## CERTIFICATE OF APPROPRIATENESS

As you are aware, the Historic Preservation Commission gave Final Design Review approval for the work you are proposing for the Scott Apartments and Garage at 900 S. College Avenue at its January 19, 2022 Regular Meeting.

## HISTORIC PRESERVATION CERTIFICATION APPLICATION PART 2 – DESCRIPTION OF REHABILITATION

**1. Historic Property Name** The Scott Apartments

existing 54" x 56<sup>3</sup>/<sub>4</sub>" Window sash & jamb  
scale 1<sup>1</sup>/<sub>2</sub>" = 1'

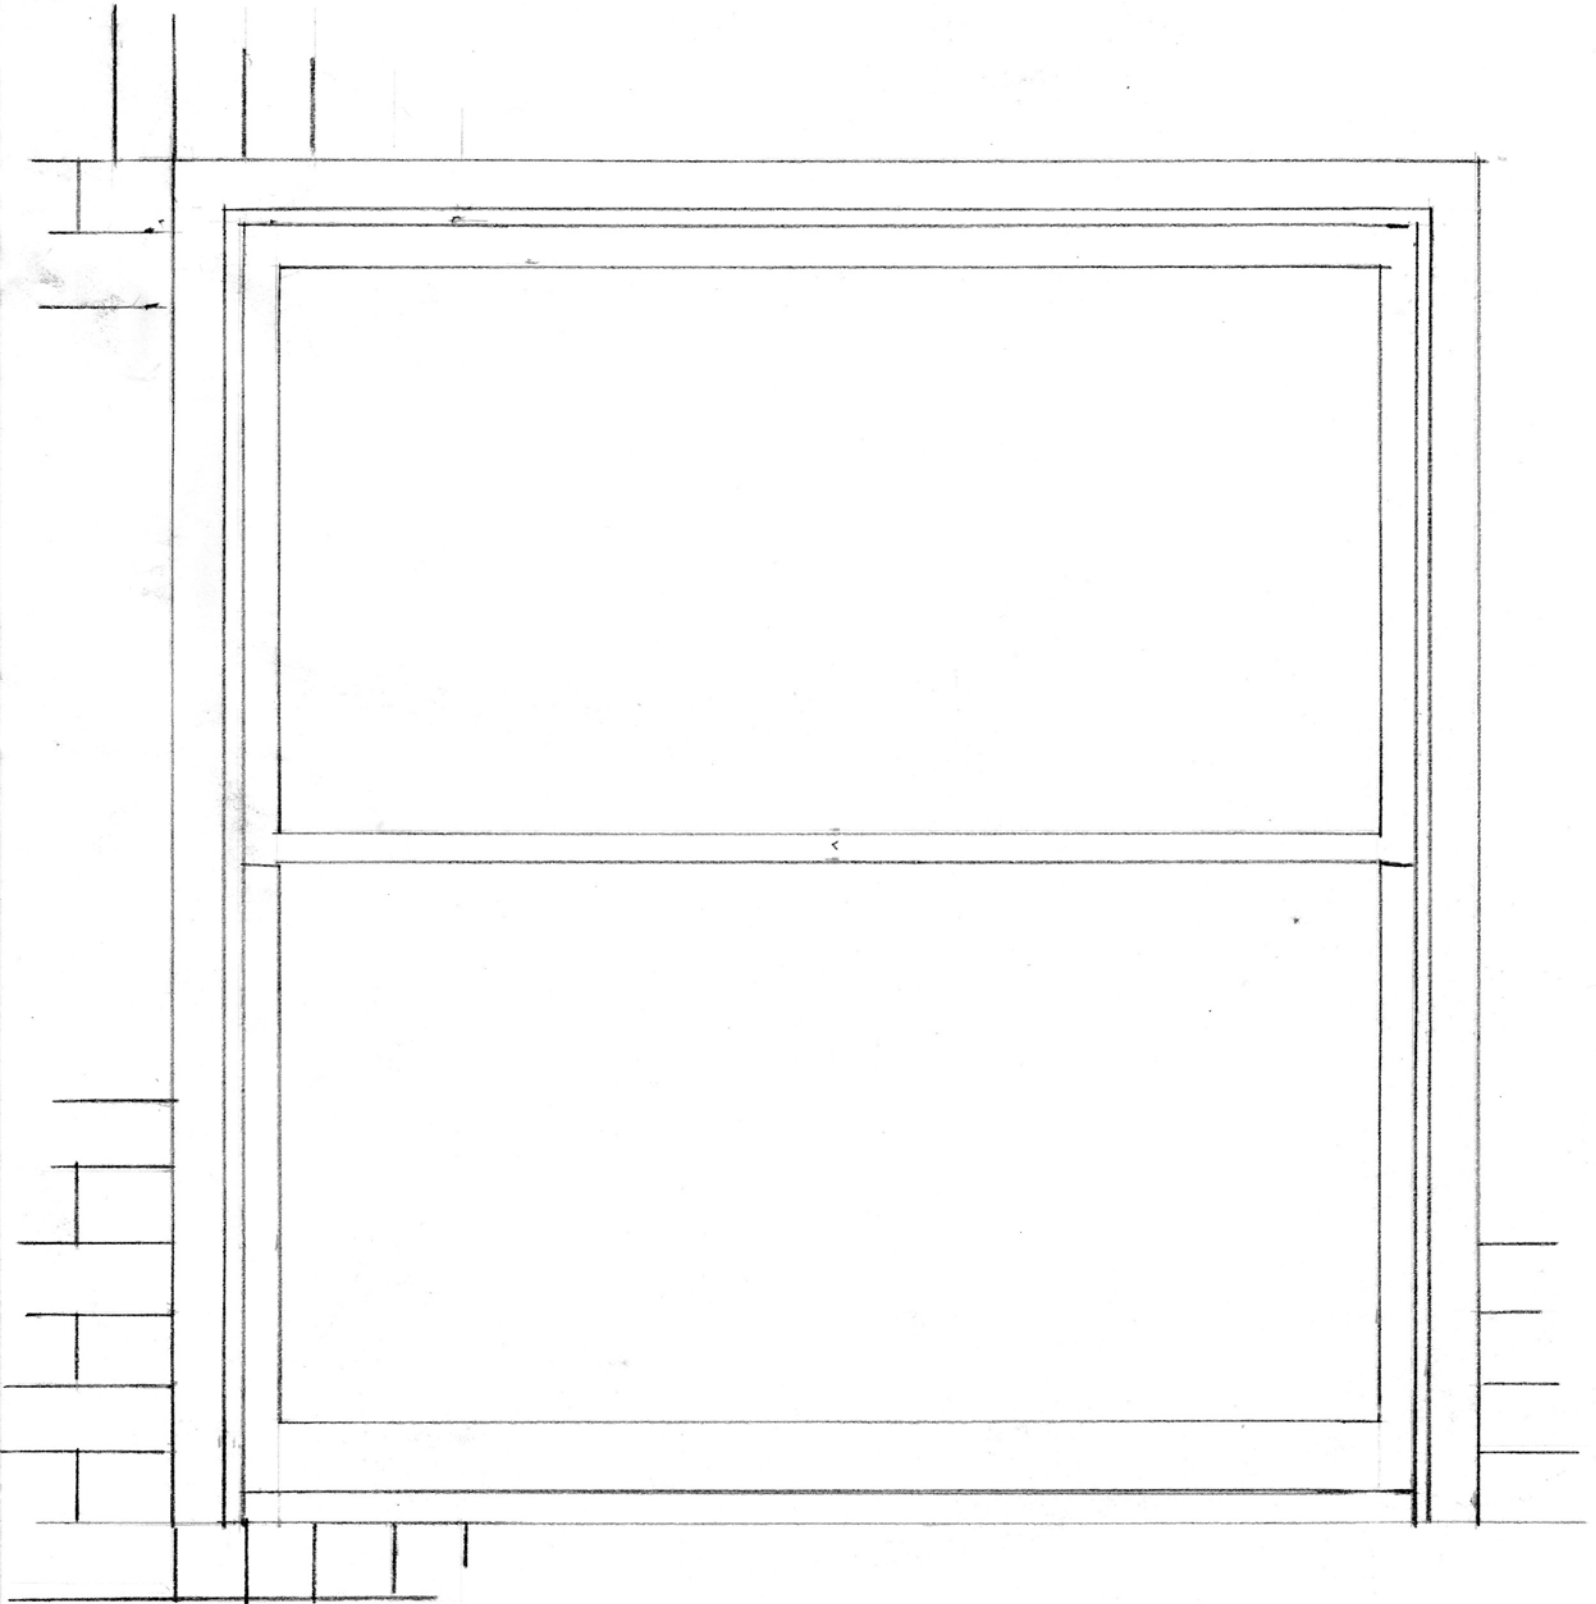
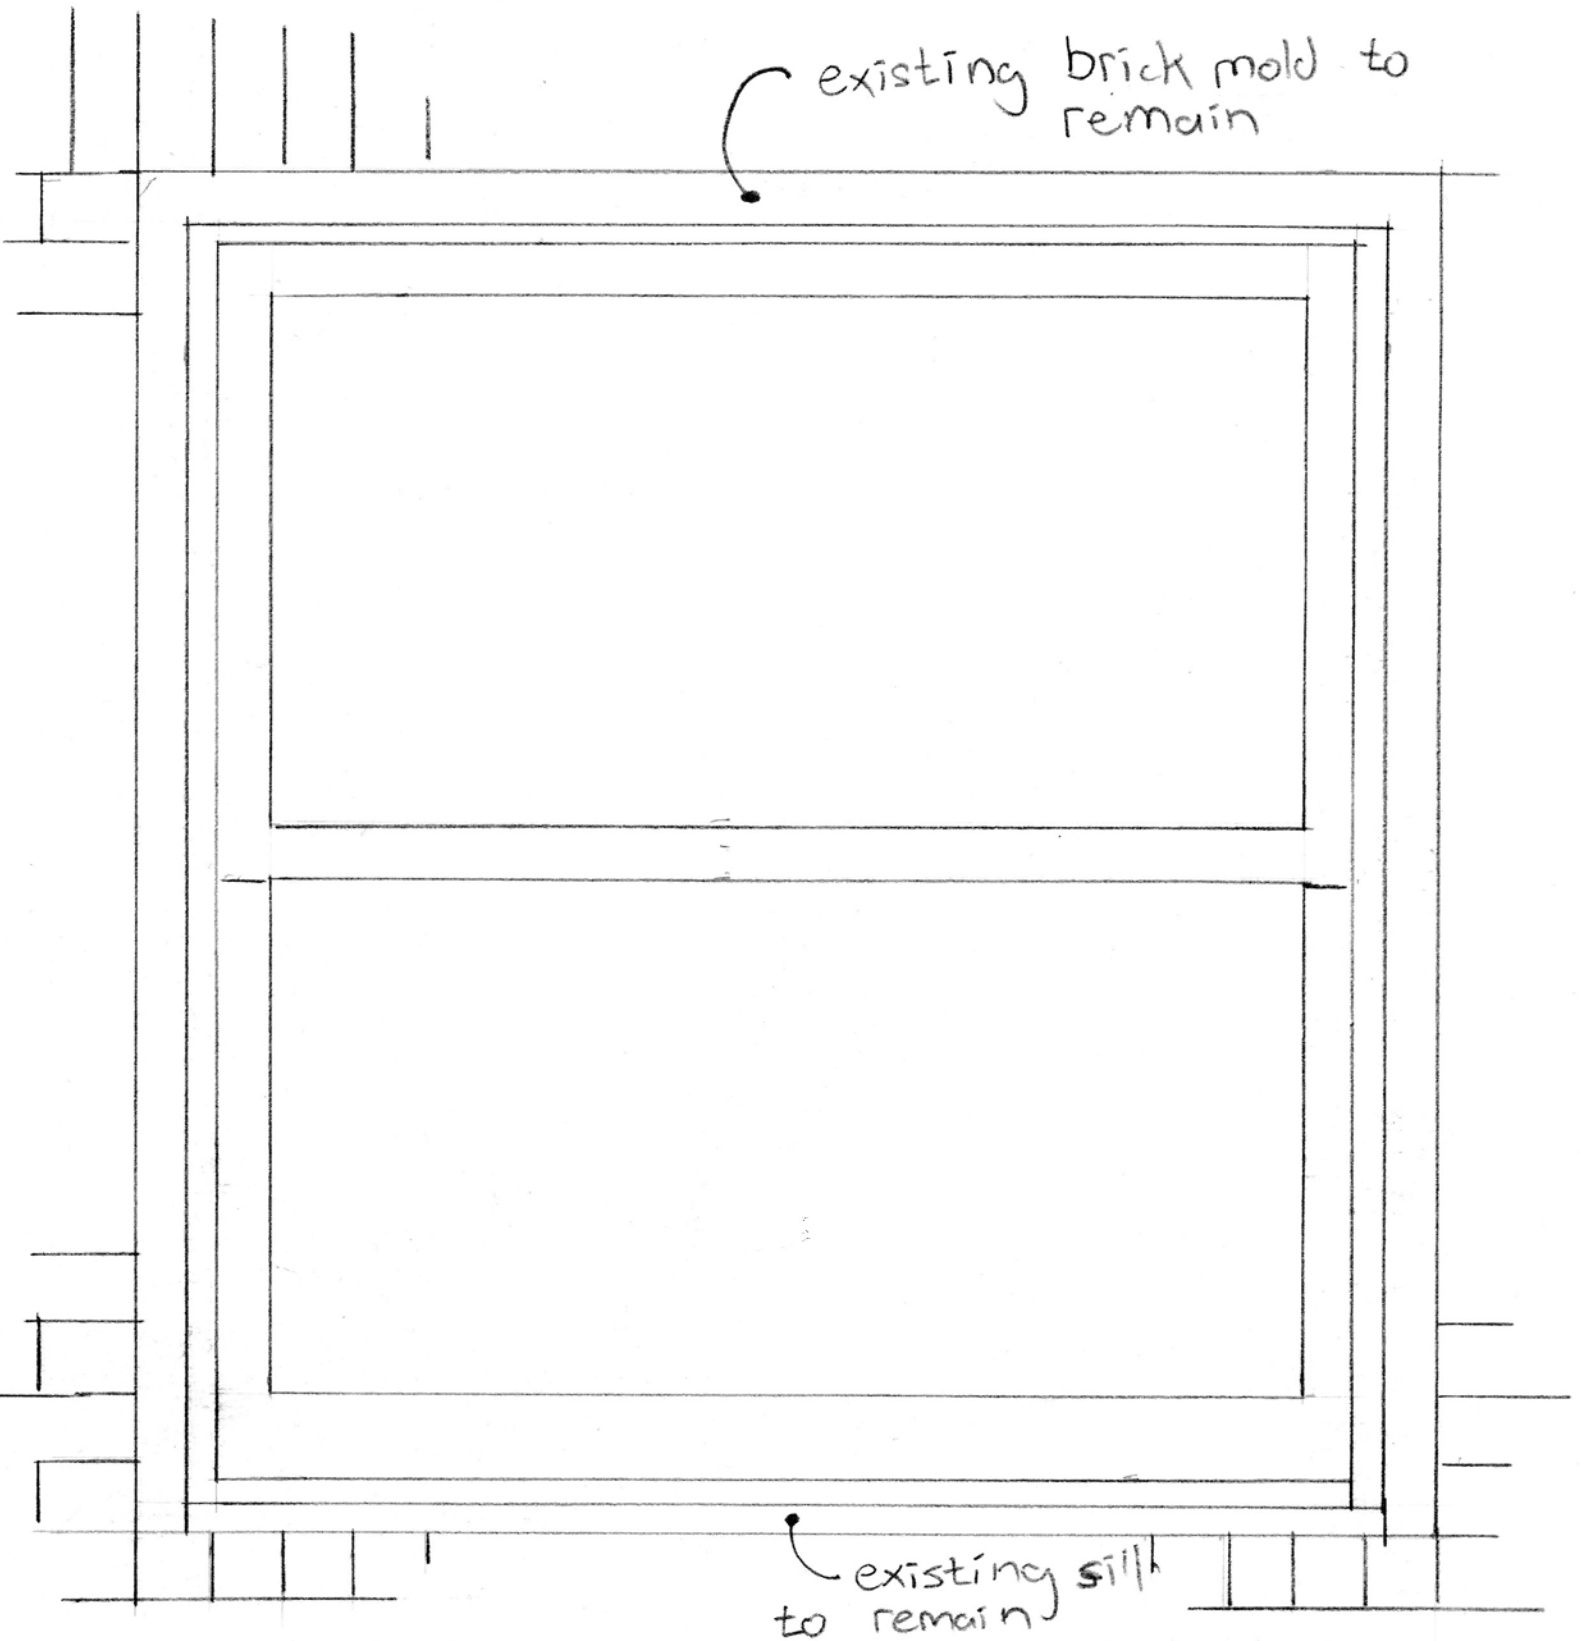
- Installation of interior storm windows on most window units
  - Replacement of large living room windows in units 1-10 and 14 with Marvin Magnum wooden block frame units to accommodate fire ingress/egress.

The large living room units in apartments 1-10 and 14 will be replaced in kind with new Marvin Magnum wooden block frame units. This will involve removing existing damaged sashes and window stops. Existing window jambs, sills, and exterior brick molding will remain. New units will be secured within the existing window jamb and painted to match the original windows. Existing screens will be re-installed in their original location within the existing brick molding.

Portico Wall Detail  $\frac{1}{2}'' = 1'-0''$

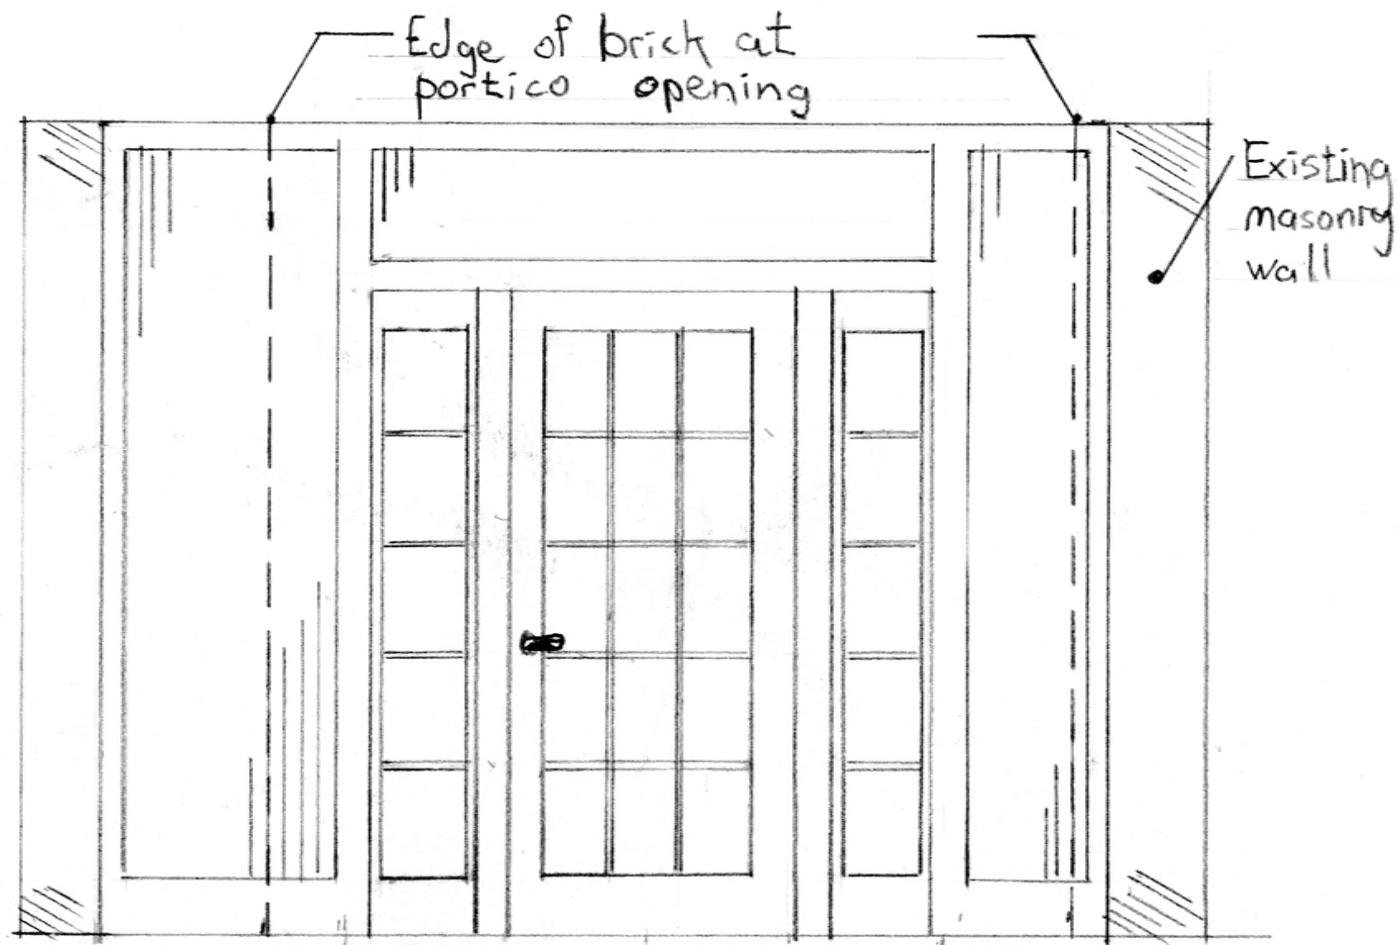
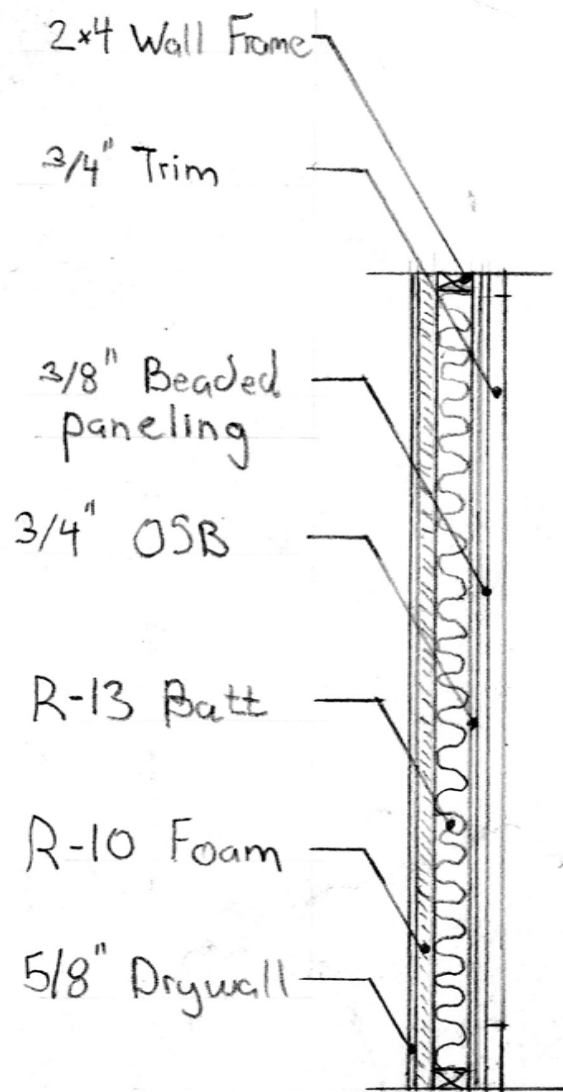
- On rear/east entry enclosure, could you clarify materials and design? (Staff's read of the plans was that you're effectively replicating the existing entry with the new vestibule enclosure, but if you could confirm/correct/clarify, that should address this question).
- On plywood infill of bathroom windows for ventilation, can you provide any example images to help visualize?

I am attaching a detail I provided for the tax credit application. I may have failed to include this when I sent you material earlier. The door and sidelights will be painted wood similar to the existing entry. Infill panels will be vertical beaded wood.
